Re: Fourth Submission Review – Avelon – FDP and Comprehensive Plan Amendment
Application Number: DA-2121-00
Case Numbers: 2018-1005-00; 2018-7004-00

Fourth Submission Review

UDFCD Maintenance Eligibility Program Referral Review Comments

Project: **Avelon**
Stream: **Weasel Drainage**
UDFCD MEP Phase: **Design**
UD MEP ID: **ID 10003722**

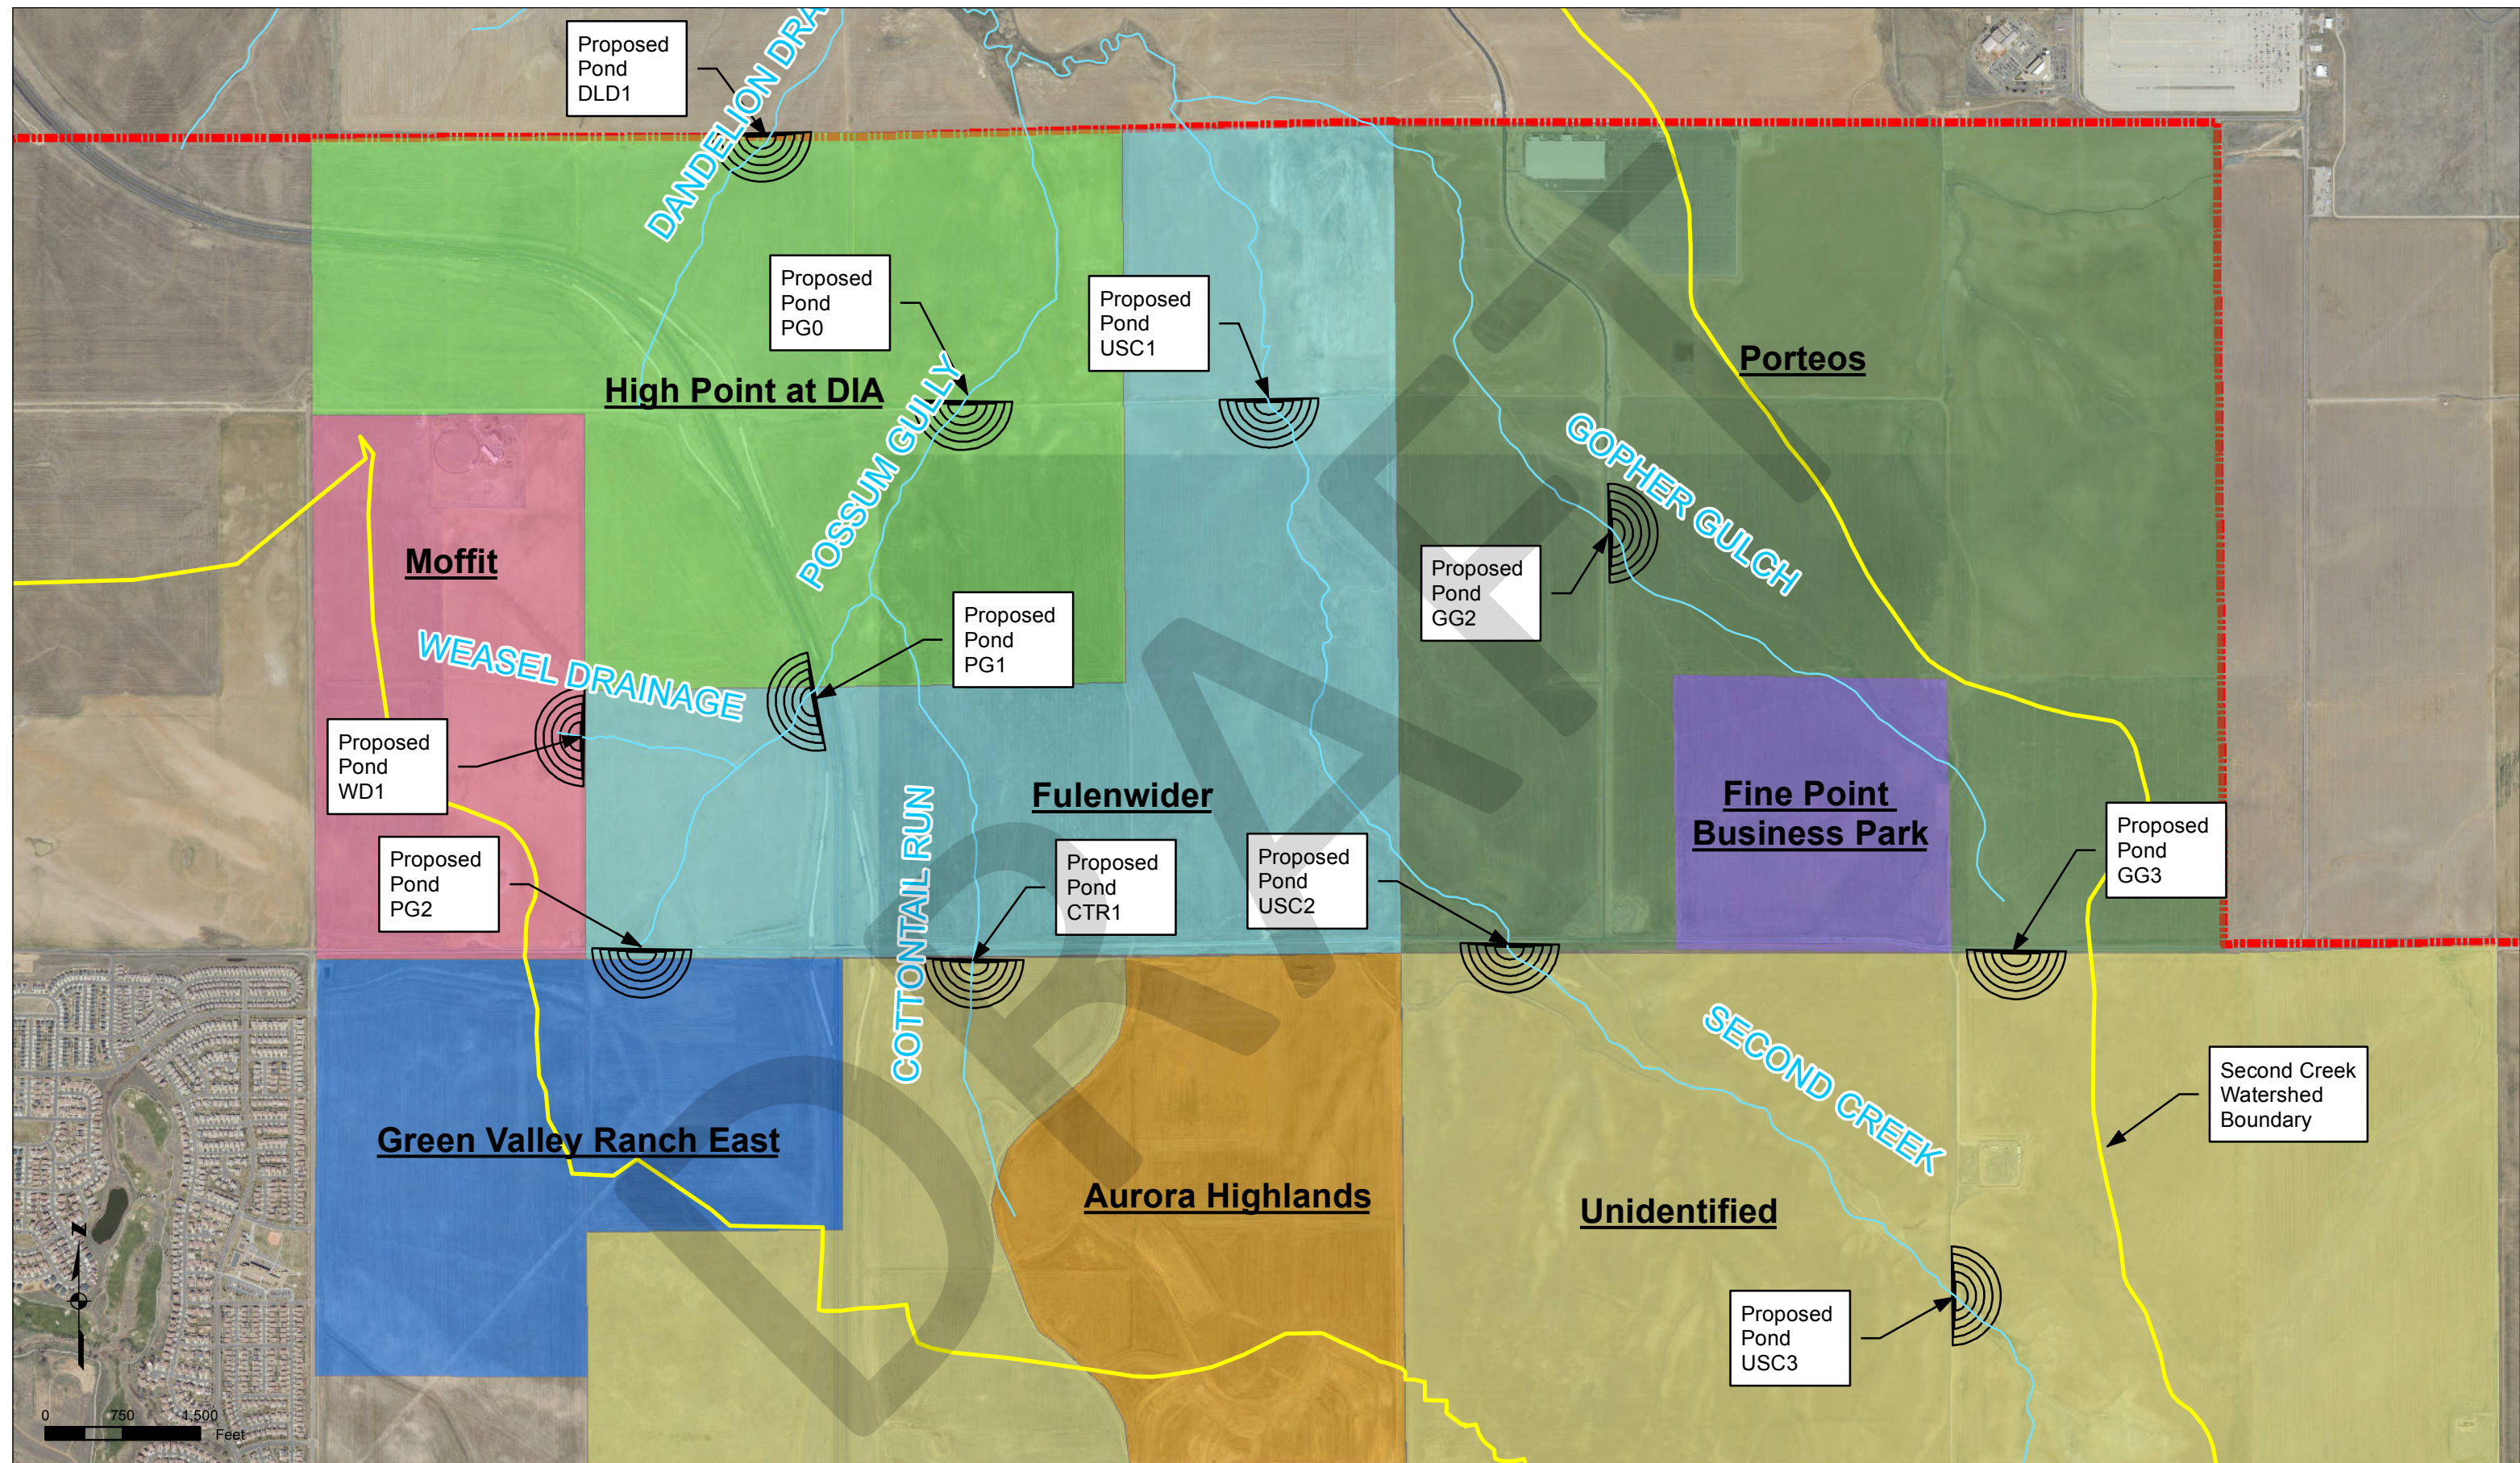
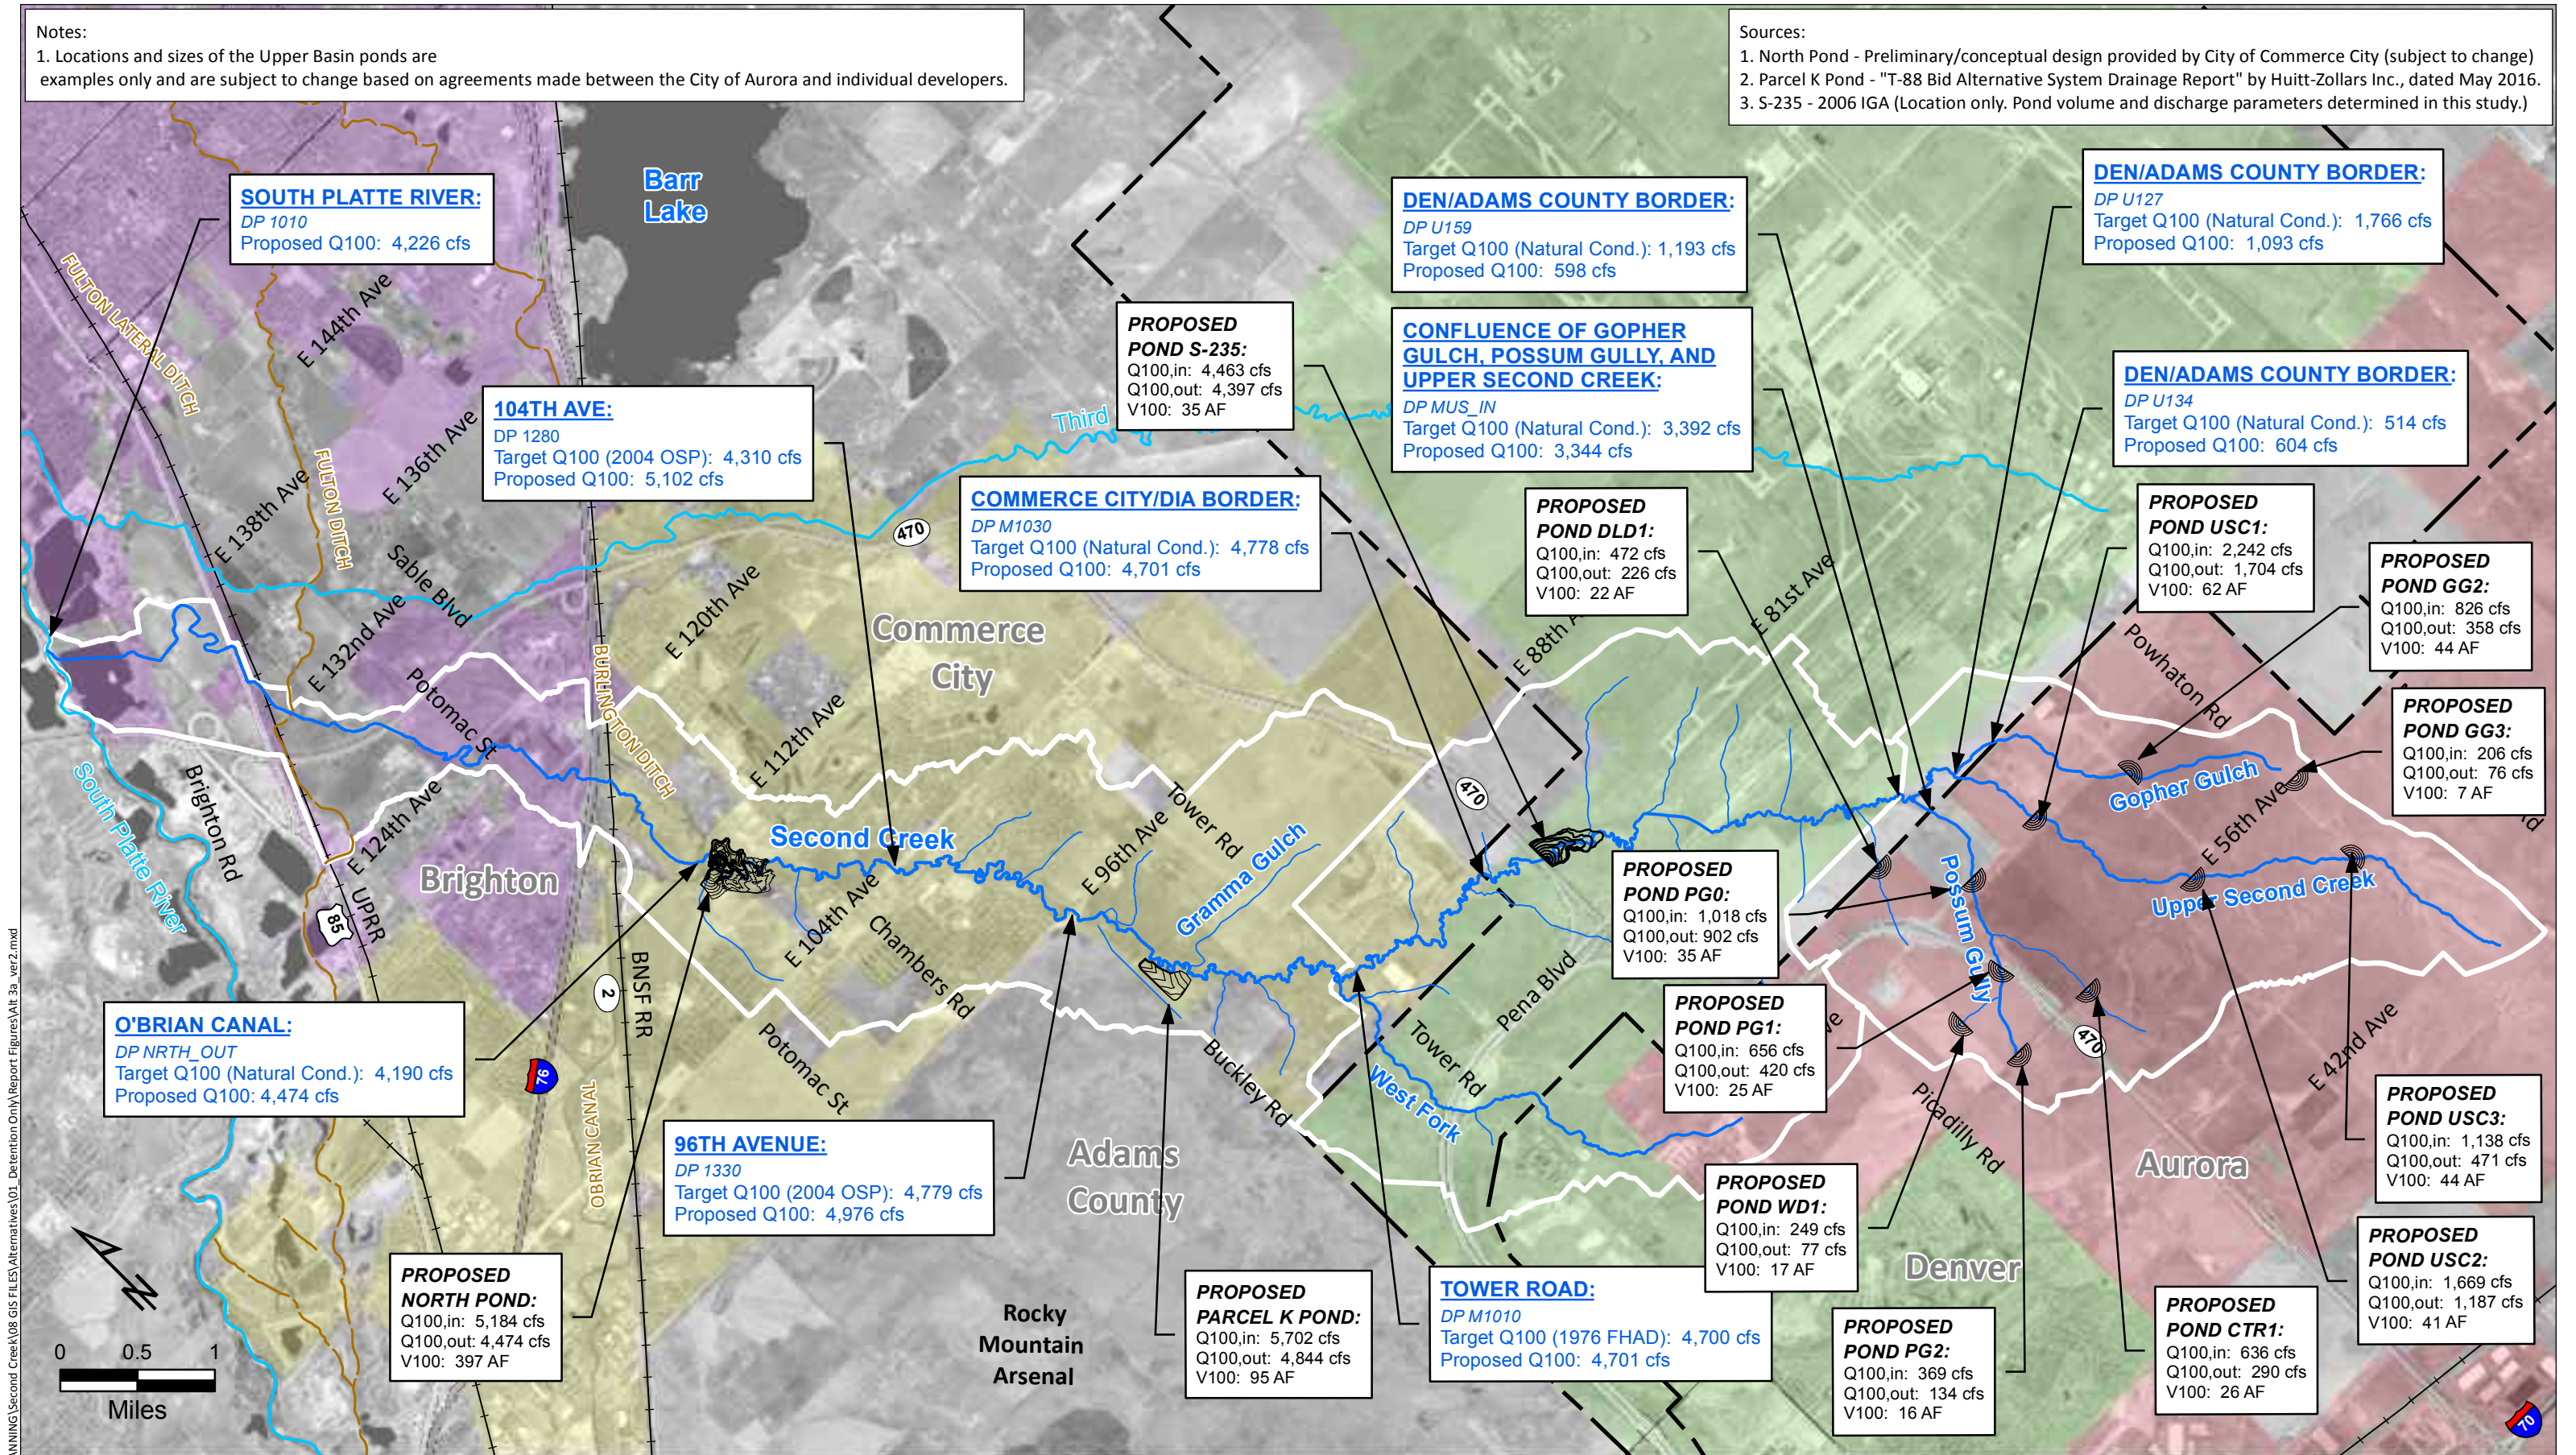
1. Although it did not appear that there were any substantive changes related to drainage on this submittal, I did want to add the following comments related to regional detention:
 - a. Please keep the following intent of the current ongoing RESPEC Second Creek master plan in this area in mind as this plan further progresses:
 - i. To reduce flows draining on to DIA downstream of the confluence of Gopher Gulch, Possum Gully, and Second Creek to natural conditions flows of approximately 3,400 cfs. Weasel Drainage is tributary to this system via Possum Gully.
 - ii. To evenly distribute regional detention basins amongst the various developments planned for the watershed.
 - b. Although an alternative for the Second Creek master plan has not been formally selected, all signs point towards Detention Alternative 3A being selected. I've attached

excerpts from the master plan showing the general location of regional detention basins in this area (Figure F-1), and their size (Figure 5-6). Pond WD1 is on this property.

- c. To achieve the target discharge at the DIA boundary it is important that the general location and size of the detention basins shown be adhered to, otherwise flow routing may be altered in such a way that the target discharge at the DIA boundary is exceeded. If for some reason there is a desire to reconfigure the regional detention in a way that deviates from Detention Alternative 3A either in size or location, then the modification would need to be plugged into the overall CUHP and SWMM models for the Second Creek watershed to confirm that the target discharges at the DIA boundary are still met.
